Lakes & Waterways Advisory Board Regular Meeting Tour of Stormwater Installation and Chain of Lakes

Shoreline Alteration Permit Staff Report (Boathouse)

Shoreline Alteration Permit Staff Report (Boathouse)

Application #: 19-09 WATERBODY: Lake Virginia Date: May, 2019

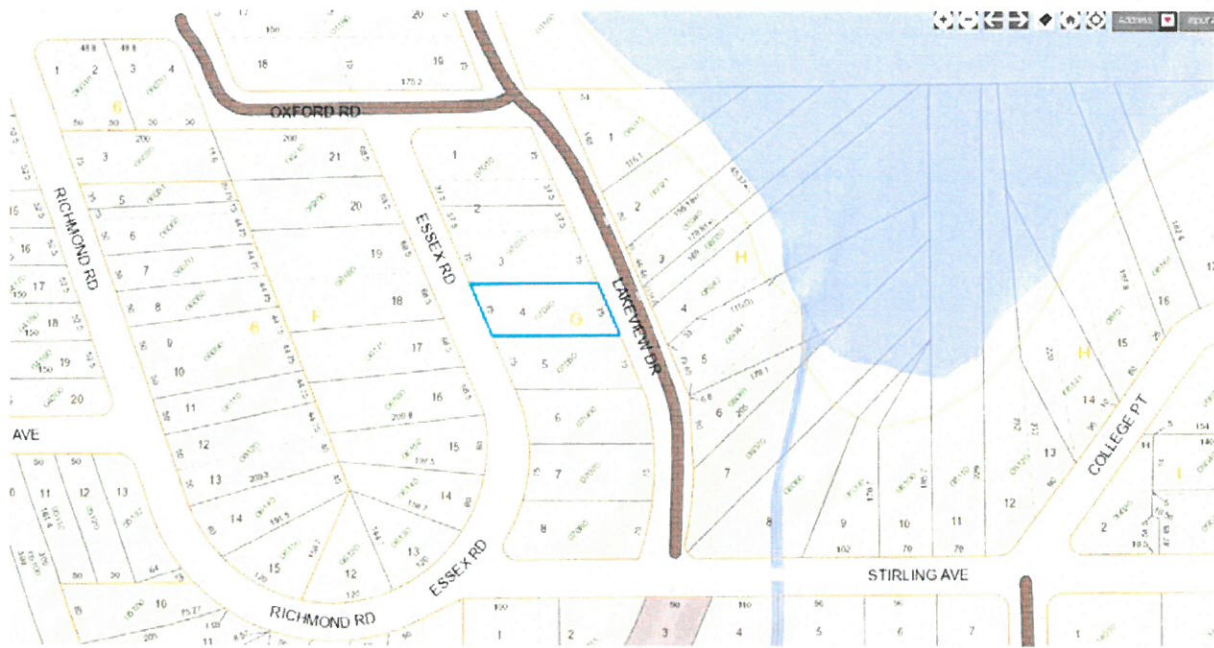
Staff recommends approval pending vegetation compliance.

Approval

Application #: 19-08 **WATERBODY:** Lake Osceola **Date:** April, 2019

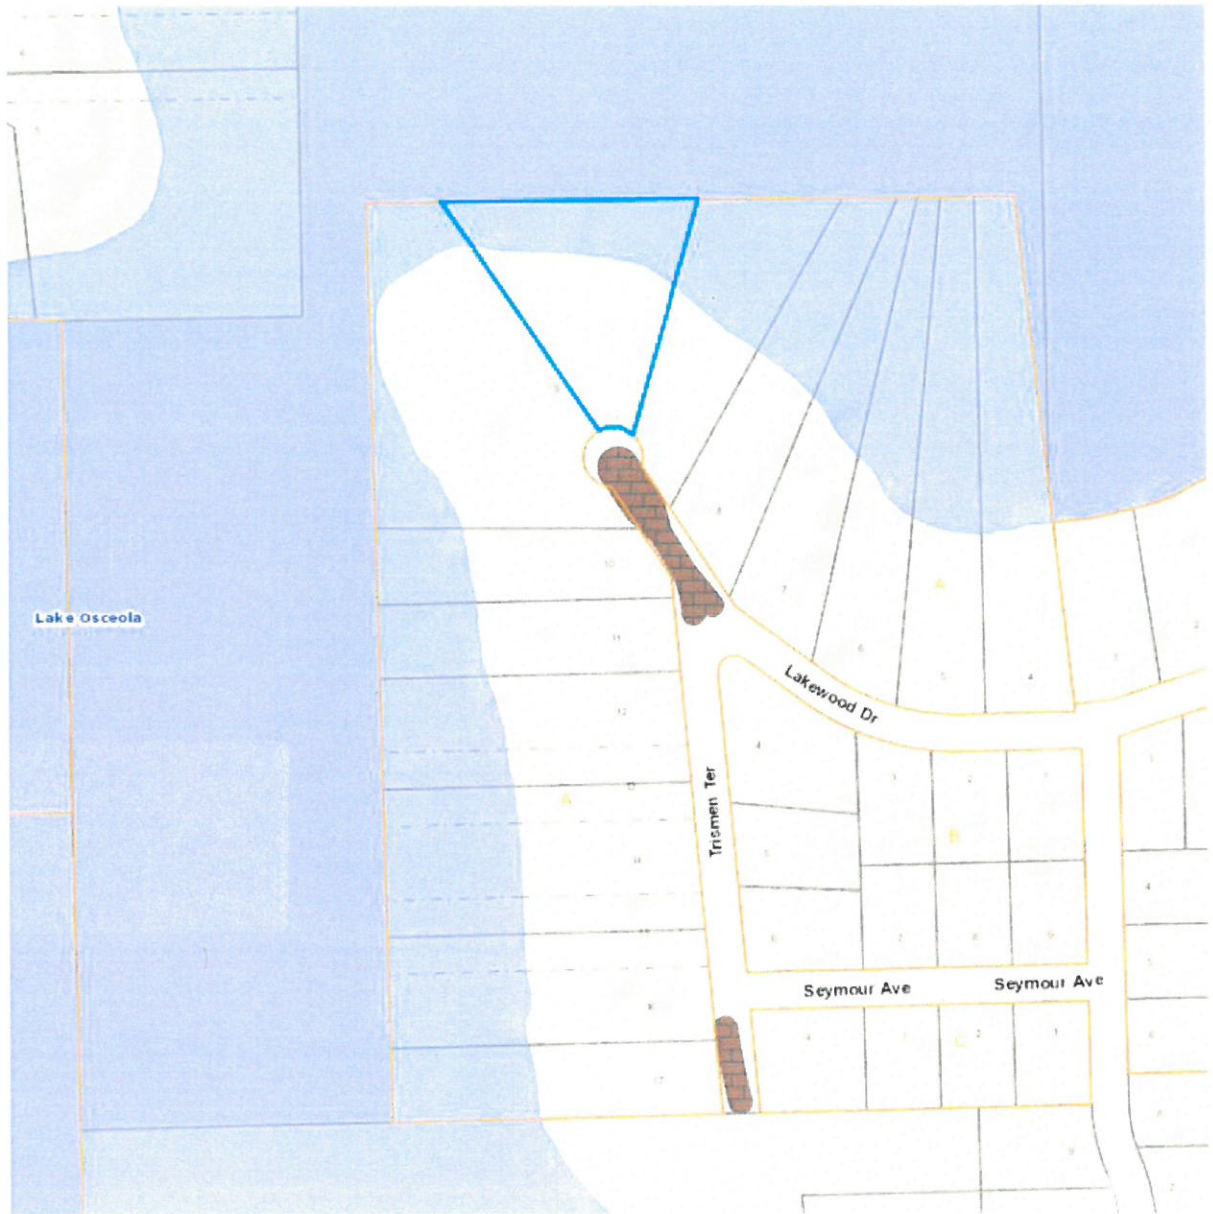
Length from OHW exceeds the allowable length, LDC Section 58-87. Flat roofs are not allowed, LDC Section 58-87. Property is not compliant with vegetation requirements, LDC Section 114.

Disapproval.
